KU-RING-GAI COUNCIL SUBMISSION
October 2010

SYDNEY ADVENTIST HOSPITAL (SAN)
WAHROONGA

Environmental Assessment
Staged Alterations and Additions
Application MP 10_0070

Figure 3 The projected points by category. (source: pg 6 App K)

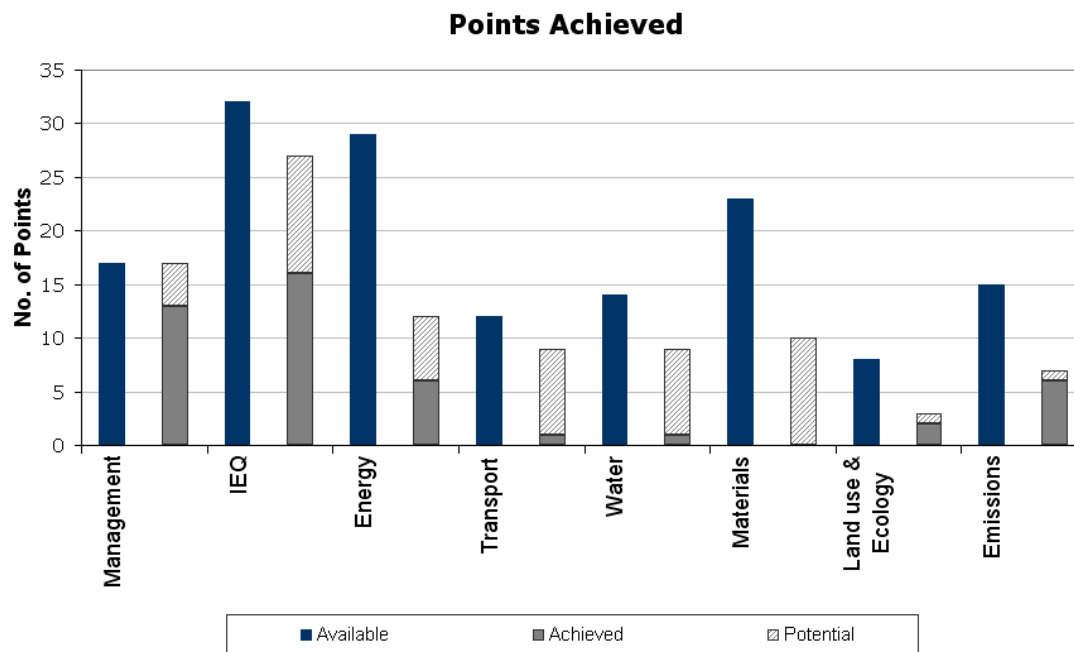
Figure 3 from the consultant's report illustrates how the assessment across each of the Green Star categories. The dark blue is the maximum achievable within each category. The dark grey indicates what this development is achieving. The light grey are the ambiguous 'possibly achievable' areas and cannot be counted on at this stage. When Green Star principles are integrated into a building development it is clear what the measures achieved will be with a small margin of extras. Where no systems are integrated into the design there is no real measure for what can be achieved. At this stage, the level of documentation should have clear indications of what the incorporated systems are, where they are located and how they will function.
